**CITY OF COBURG CITY COUNCIL
PO BOX 8316 Coburg, OR 97408**

**STAFF REPORT
Subdivision
SUB-01-20**

Report Date: August 13, 2020

FIGURE 9 – SKINNER ST AT SARA ST SIGHT DISTANCE

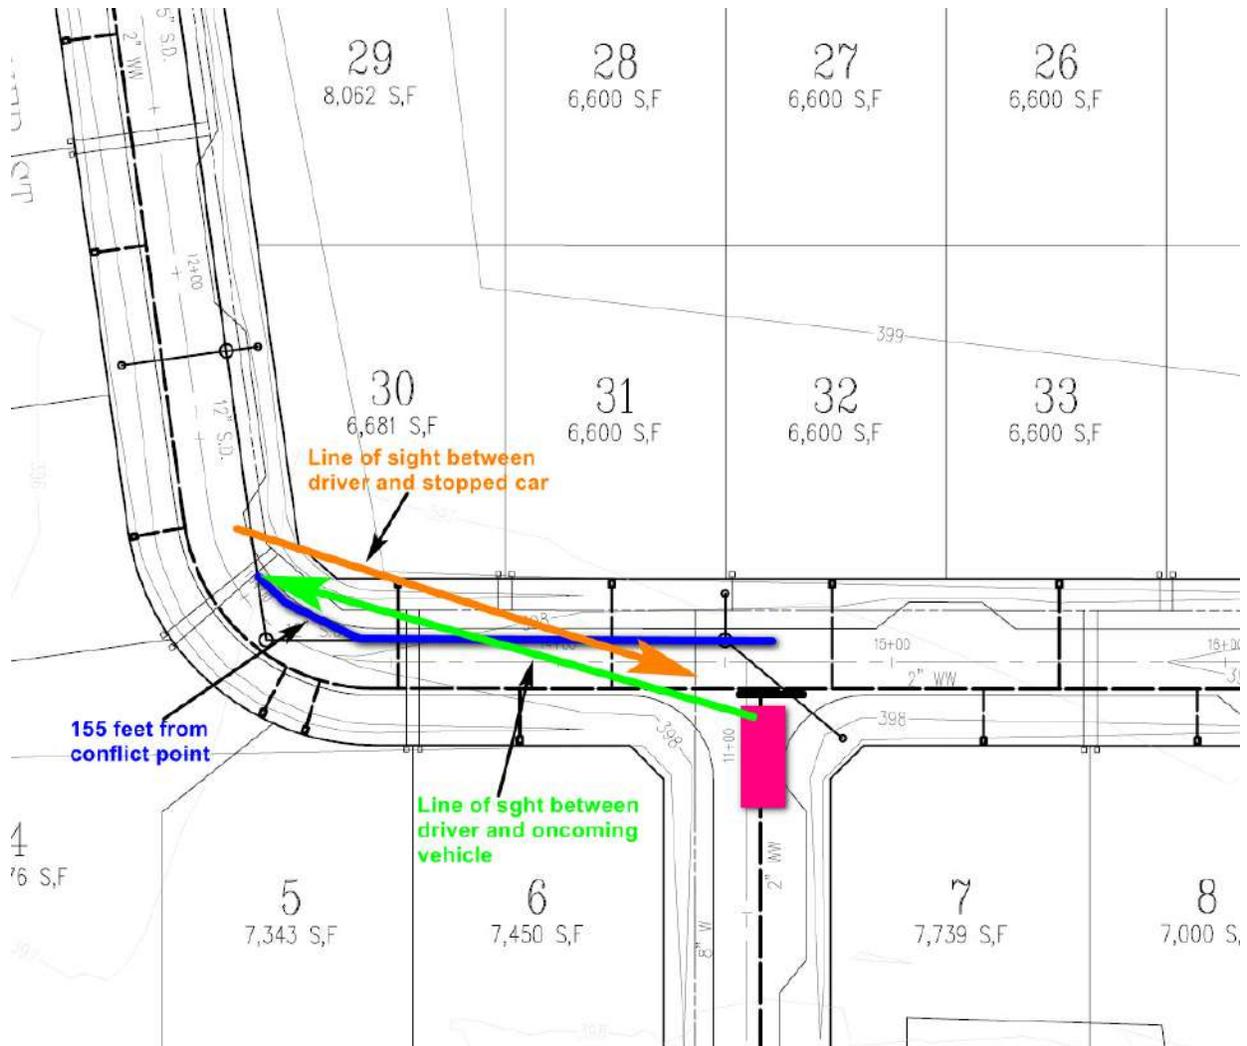
Both intersections and curves were evaluated for stopping sight distance. Figure 9 provides an illustration of the intersection of Skinner St at Sara St and Figure 10 provides an illustration of the intersection of Coleman St and Sara St. As illustrated in Figure 9, there is sufficient clear line of sight for a vehicle traveling north on Skinner St at Sarah St to perceive an oncoming vehicle from the left and judge the appropriate gap in traffic. Additionally, there is sufficient line of sight for a vehicle traveling south on Skinner St/Sarah St to see a vehicle stopped to turn onto Skinner Street at Skinner St.

The intersection of Coleman St at Sarah Street has the ability to have sufficient sight distance available. However, the line of sight cuts into the inside property. It is recommended that this area be clear of any structures that would block the line of sight, including buildings, fences and parked cars.

Additionally, it is recommended that both curves be designated as no parking on both the inside and outside of the curve to preserve the line of sight.

Finding: Figures 9 & 10 illustrate safe stopping sight distance requirements for the proposed public streets. Both figures show utilizing private property for sight distance. The TIA also recommends prohibiting on-street parking in certain areas to accommodate sight distance.
